Proposed Revisions to a Standard Plans Index

Index Number: 700-091

Index Title: Catwalk Details

INDEX
700-091

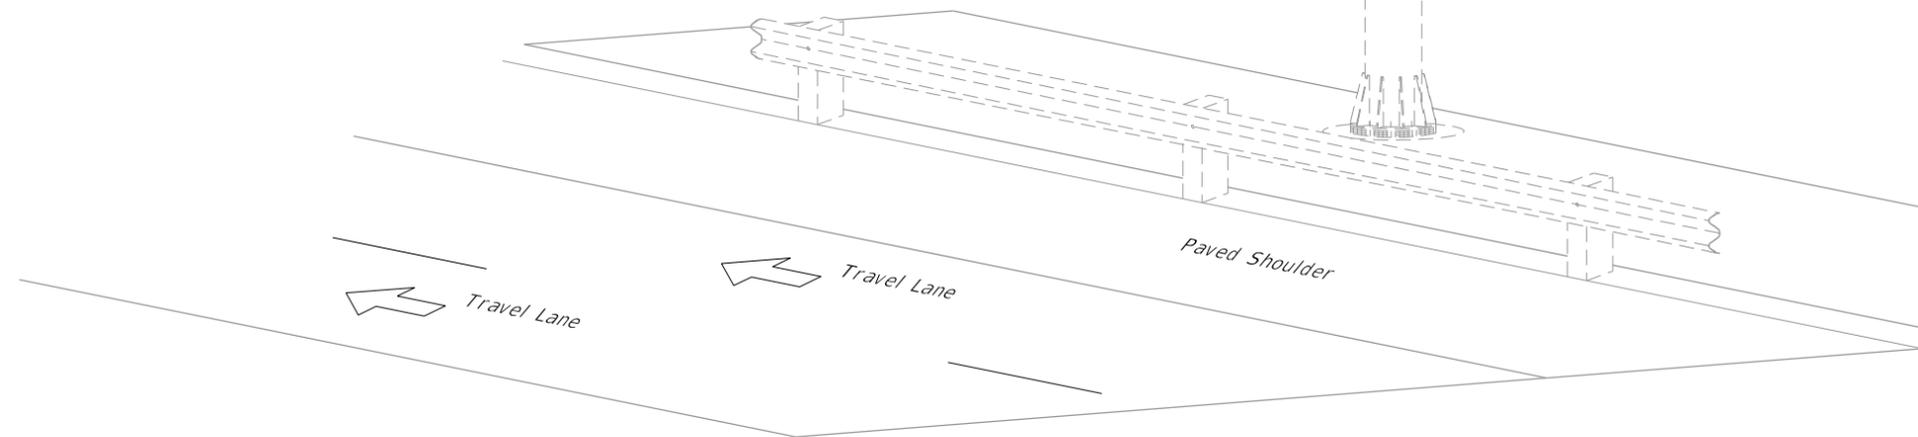
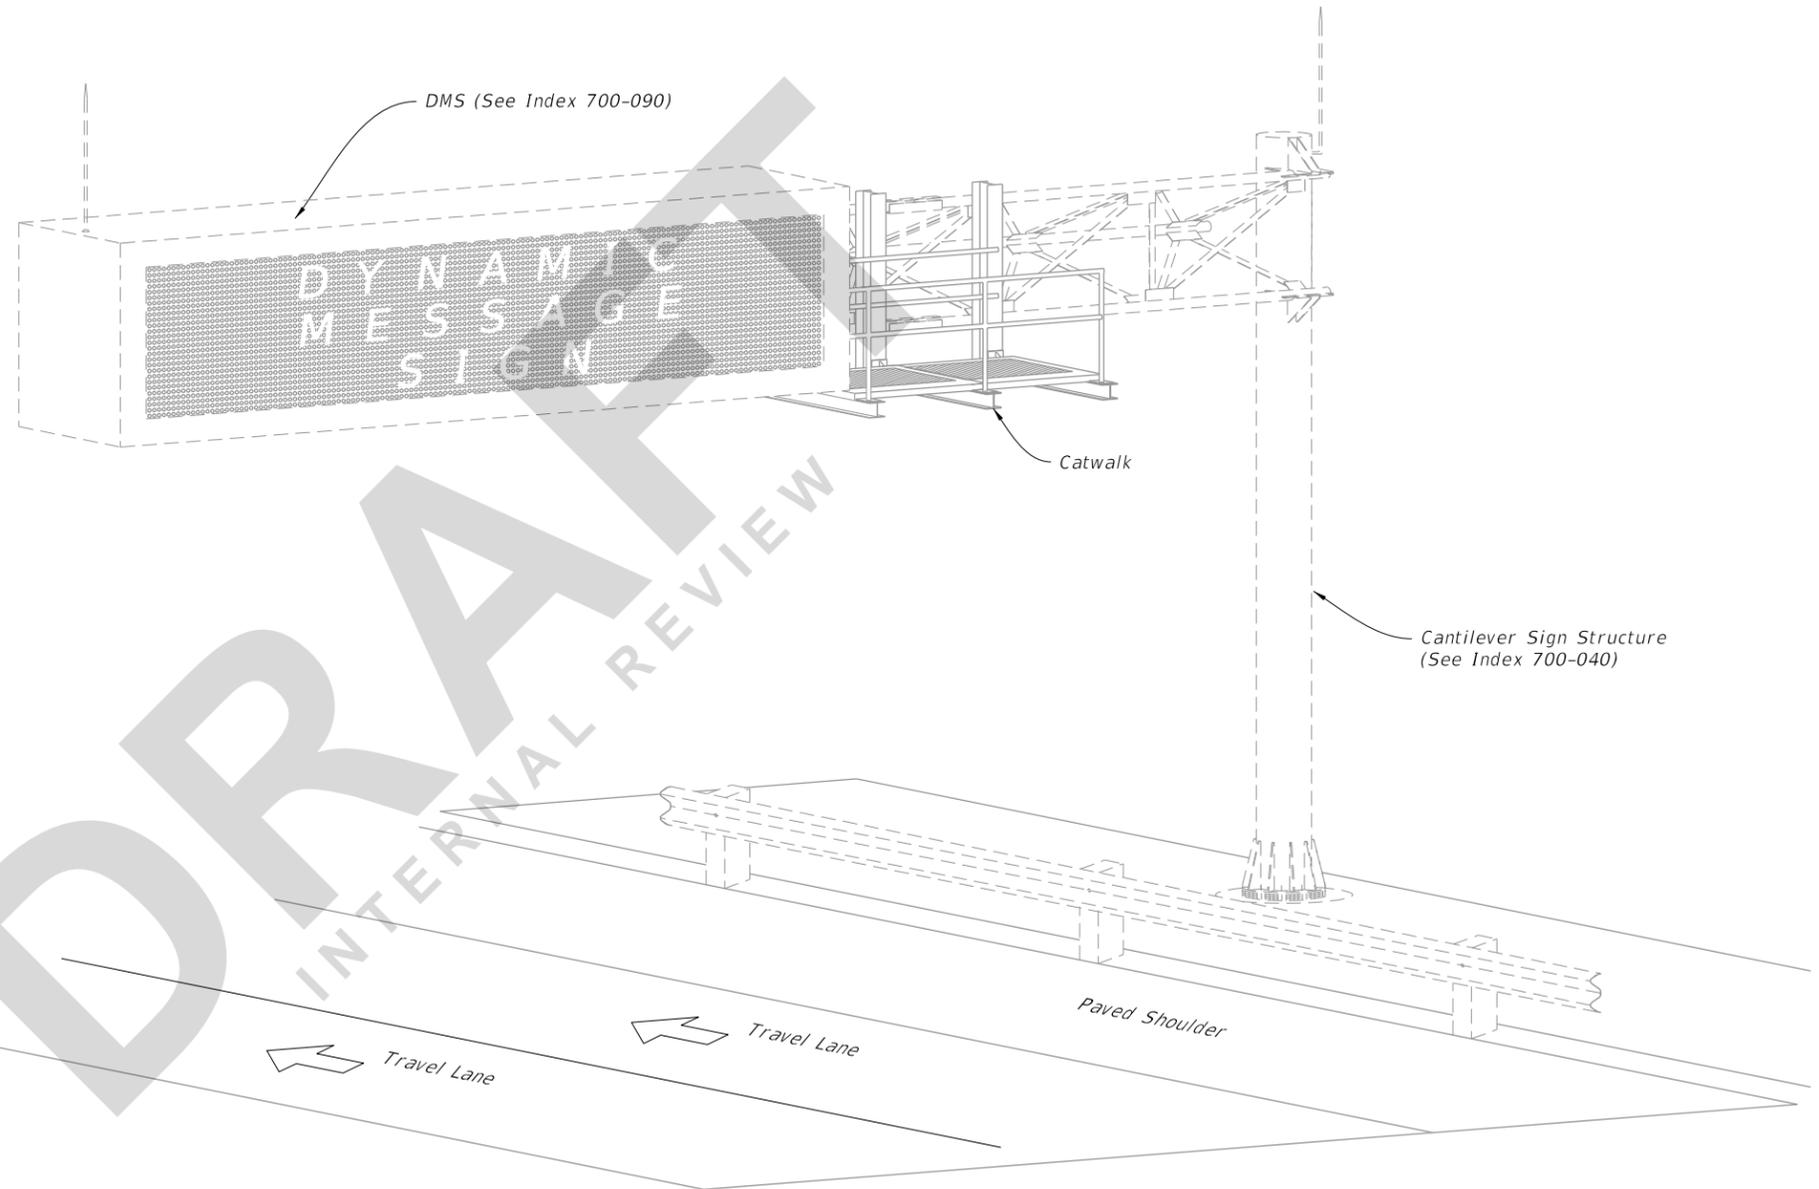
UPDATED NOTE: Meet the requirements of Specification 700.

- ~~1. Work this Index with Specification 700.~~
2. Shop Drawings are required:
 - A. Provide length as shown in the Plans
 - B. Design in accordance with AISC, AASHTO, and OSHA requirements

~~9. Welding:~~

~~10. Materials:~~

- ~~A. Steel Plates ASTM A 36 or A709 Grade 36.~~
- ~~B. W- Sections: ASTM A572 Grade 36 or 50.~~
- ~~C. Steel Pipe Railings or Structural Tubing: Specification 962~~
- ~~D. High Strength Bolts, Nuts and Washers: Specification 962~~
- ~~E. U-Bolts, nuts and washers: Specification 962~~

~~11. Coatings/Galvanizing:~~

~~Hot dip galvanize support frame after fabrication and galvanize non-stainless steel fasteners in accordance with Specification 962.~~

DELETED

GENERAL COMMENT: Some material information was deleted. Information is either already covered in Standard Specifications OR will be added to Section 700, 962 or 965 in conjunction with these revisions.

Updated General Note 1 - "Meet the requirements of Specification 700."; Deleted Note 9 through 11; Renumbered General Notes.

The 700 Index Series is being edited to remove material information and other information that is located in the Standard Specifications. Revisions are being made to Specification Sections 700, 962 and 965 in conjunction with these changes.

1. Meet the requirements of Specification 700.
2. Shop Drawings are required:
 - A. Provide length as shown in the Plans
 - B. Design in accordance with AISC, AASHTO, and OSHA requirements
